# City of Richmond

## Report to Development Permit Panel

**Re:** **Application by 0908206 BC Ltd. for a Development Permit at 9560, 9580 and 9584 Granville Avenue**

**1. DP 16-741329 - 16-UNIT TWO-STORY TOWNHOUSE DEVELOPMENT**

**PROPOSED TOWNHOUSE**  
9560 9580 9584 Granville Avenue  
Richmond, British Columbia  
Canada  
Drawing title  
**AMENITY AREA**

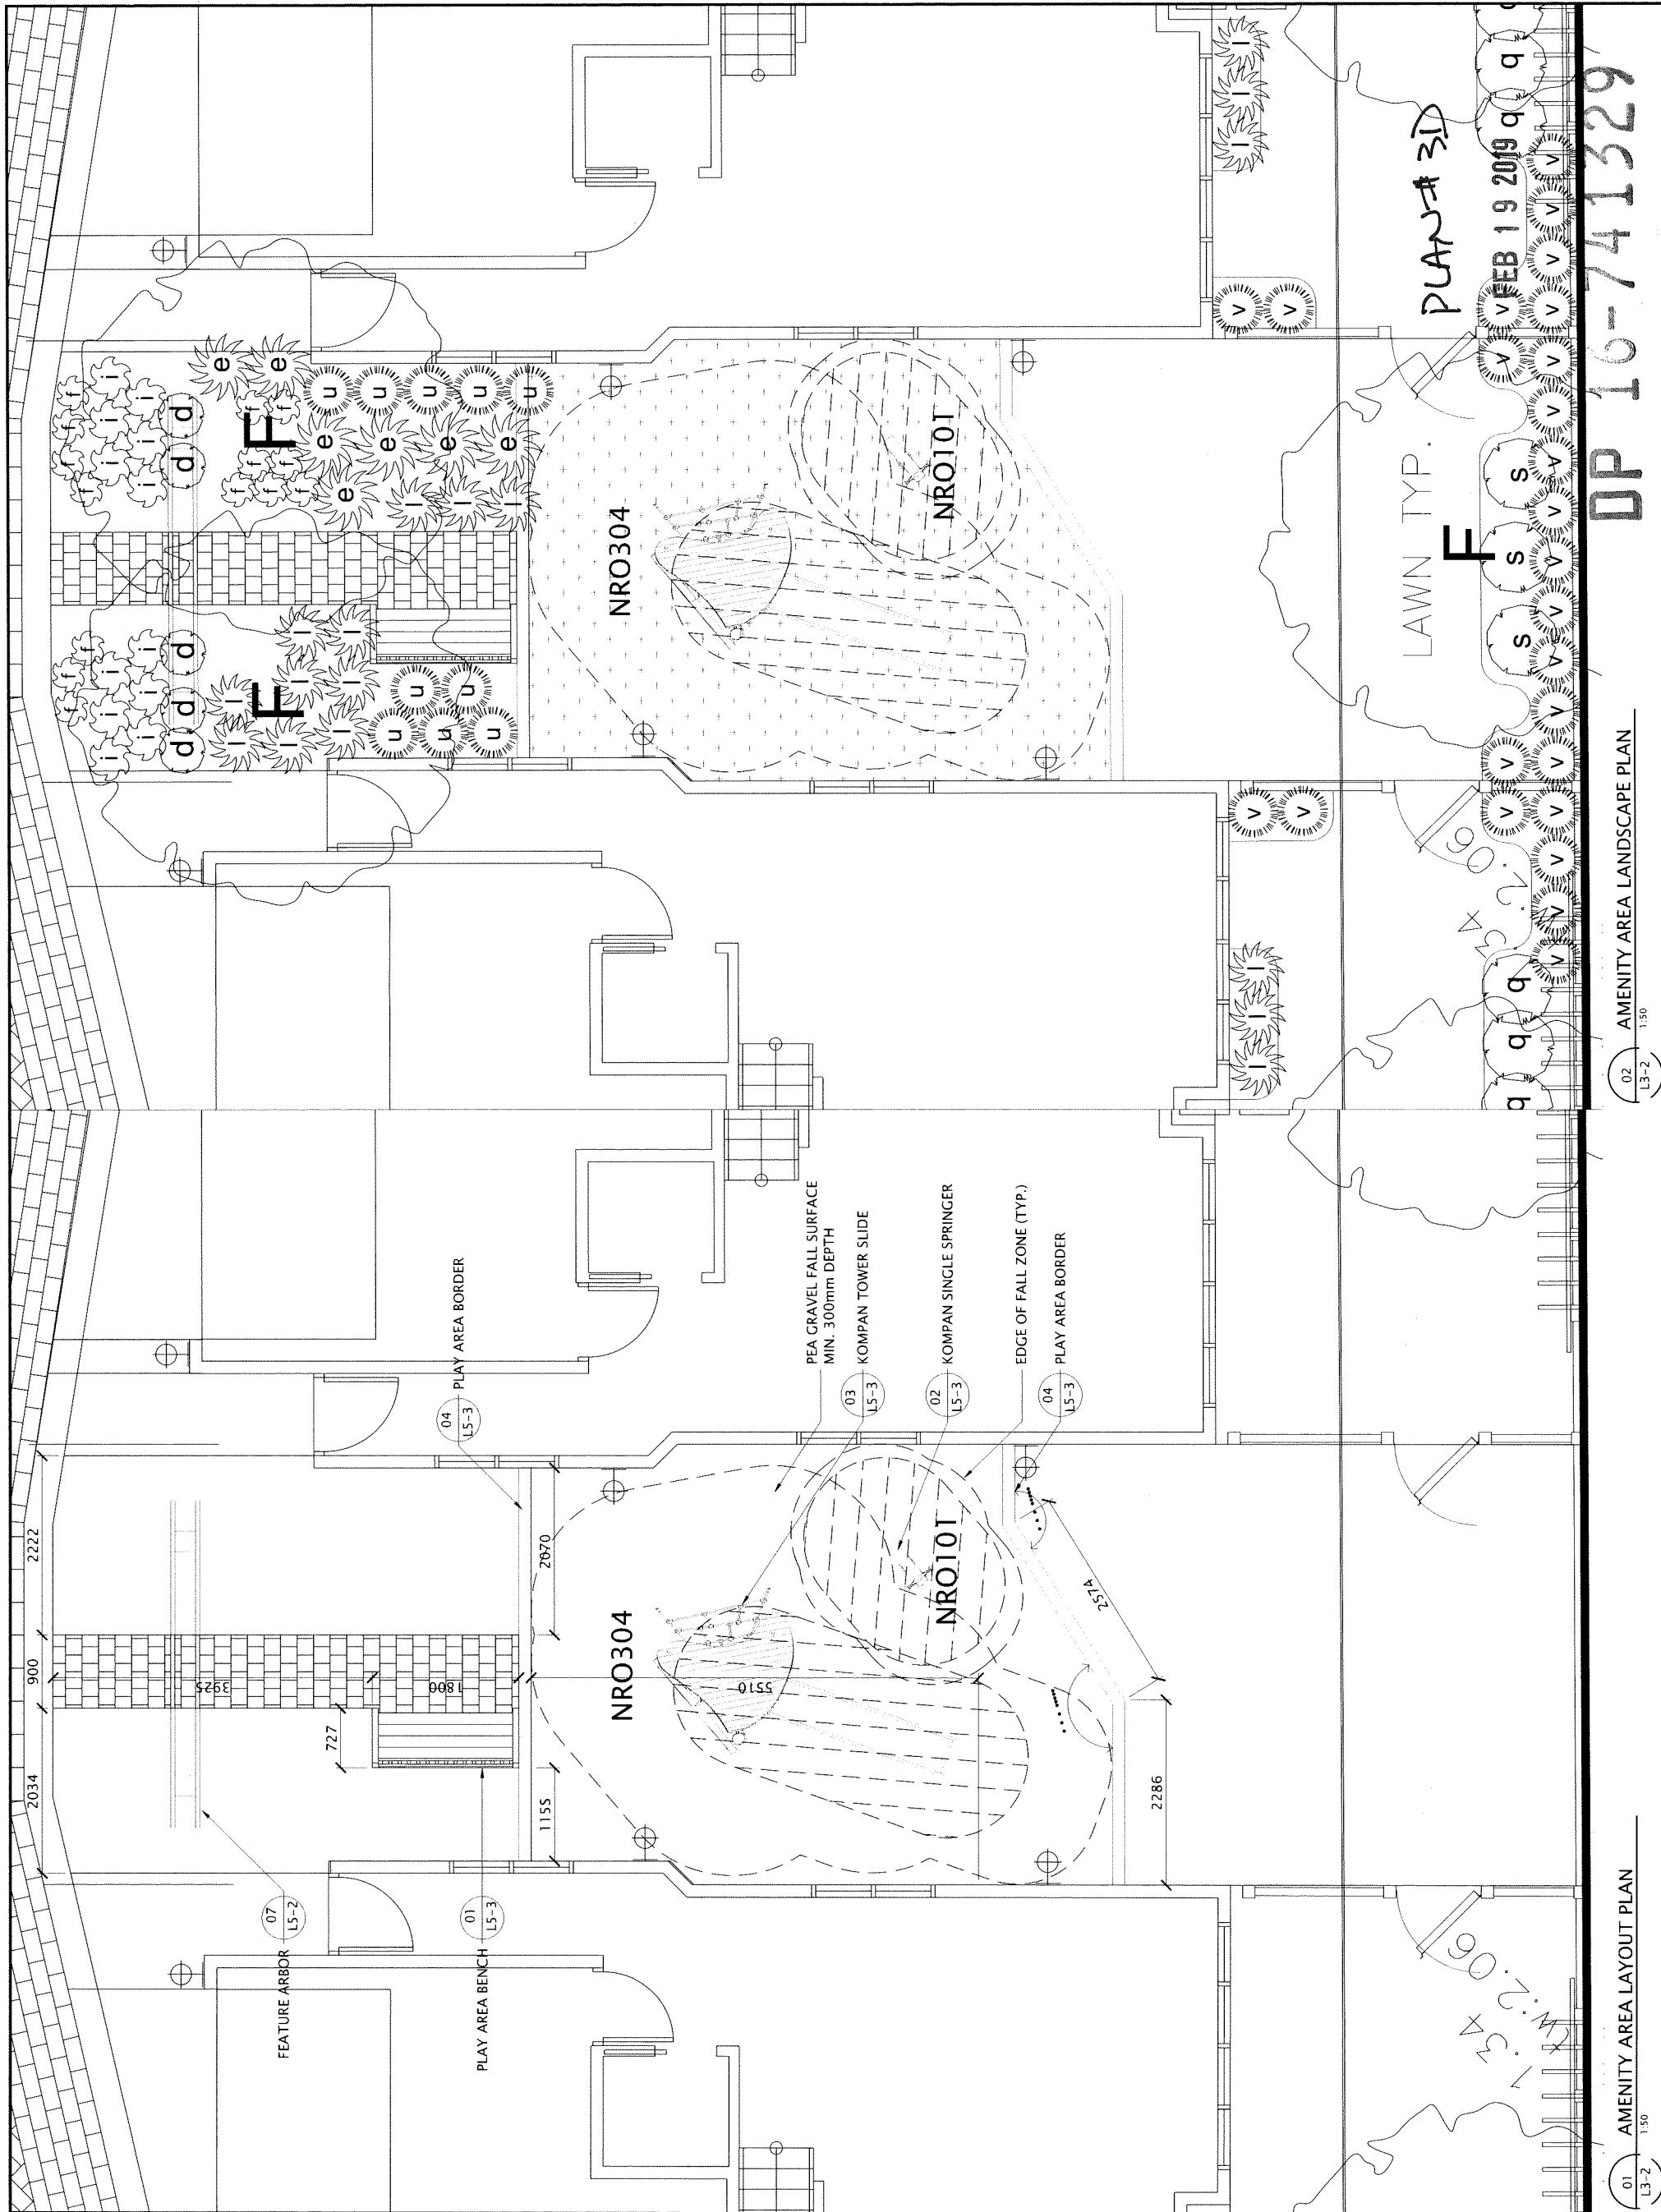
- consider relocating the proposed tree and plantings at the back of the outdoor amenity area to the edges to open up the lawn area and provide more play space for children;

- consider less prescriptive but more interesting and intuitive play opportunities for children at the outdoor amenity area;

***Landscape on the outdoor amenity area has been updated.***

***Please see revised landscape plan.***

**PROPOSED TOWNHOUSE AT**  
**9560-9584 GRANVILLE AVE**  
**RICHMOND BC**  
**UNIT PLANS**

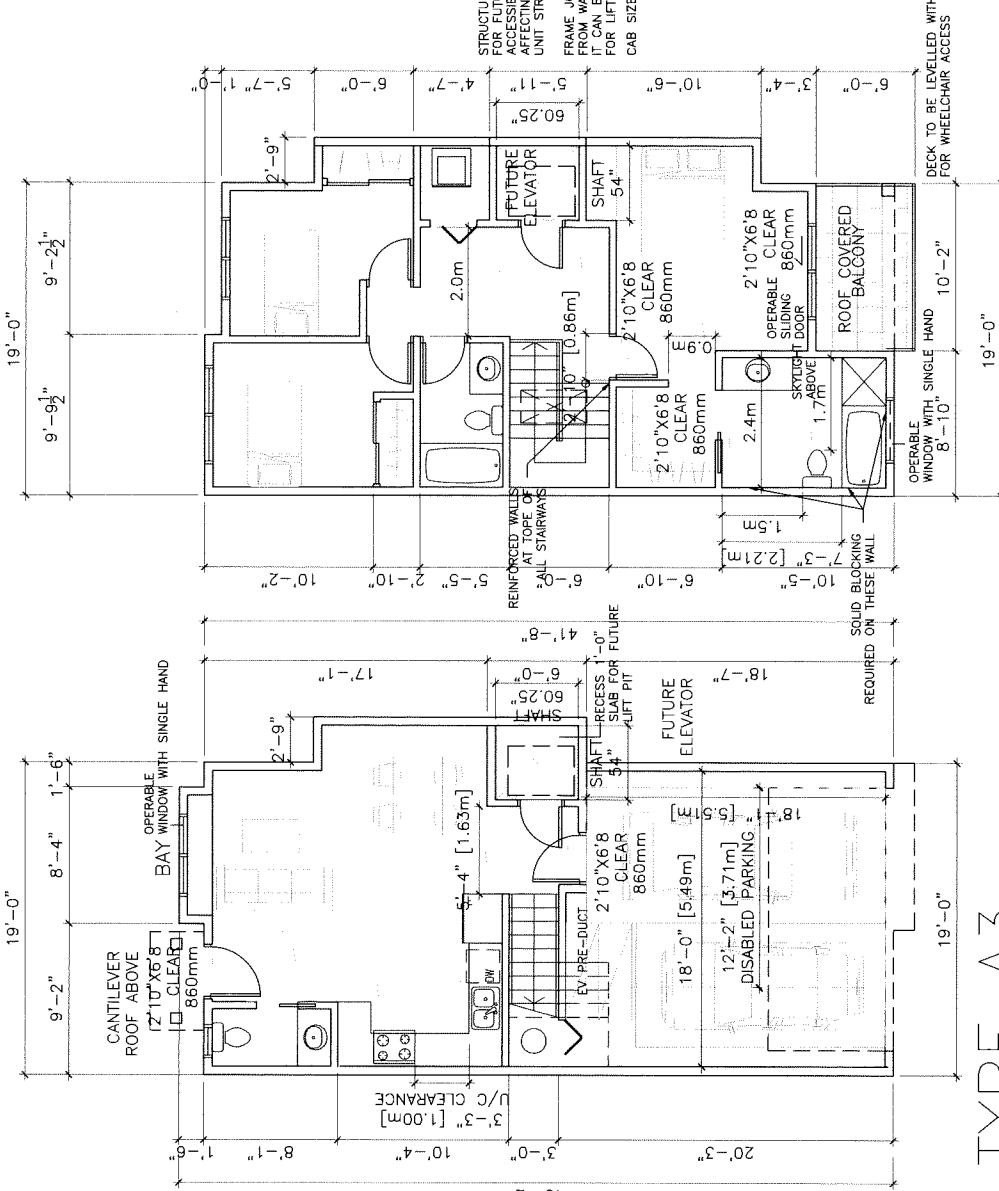
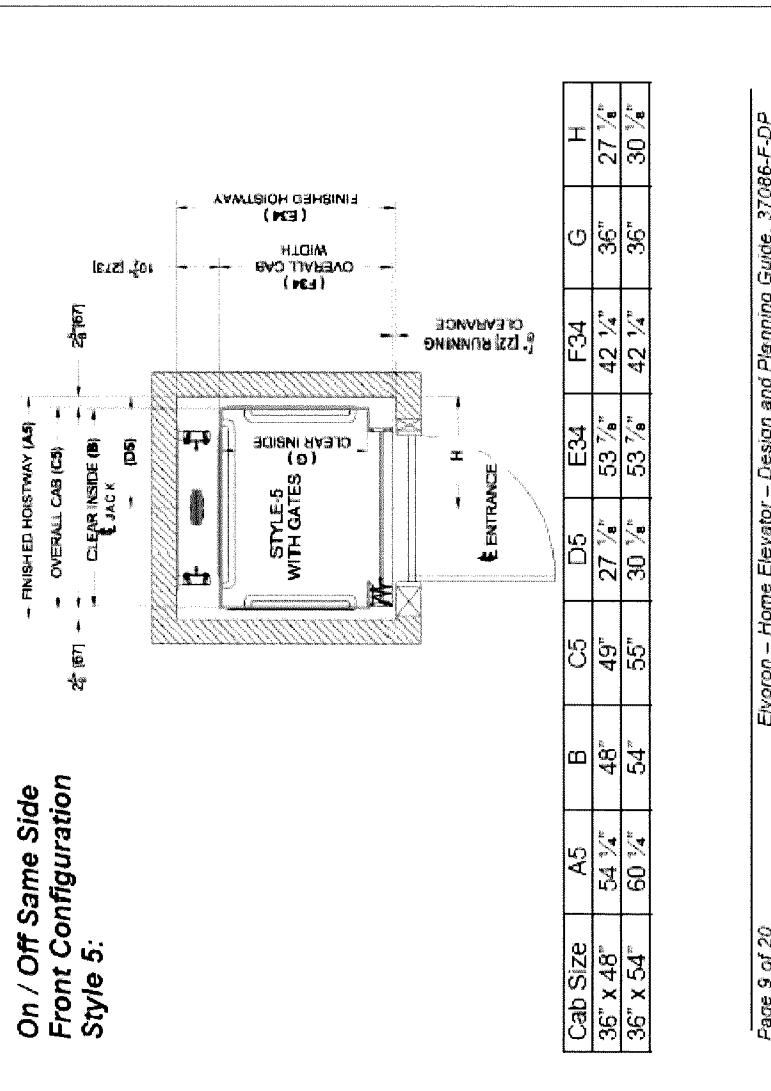
- appreciate the proposed two-storey massing for the townhouse development; also appreciate the detailing of the two convertible units; however, consider (i) integrating the bump out for the future elevator with the usable ground floor space of the convertible unit to provide additional space for the dining area, and (ii) relocating the front door entrance on the ground floor to increase the size of the powder room and the width of the sliding door to enhance accessibility;

*The dining area is bumped out to provide additional space. The powder room is enlarged slightly and closet removed to provide easy access to the powder room.*
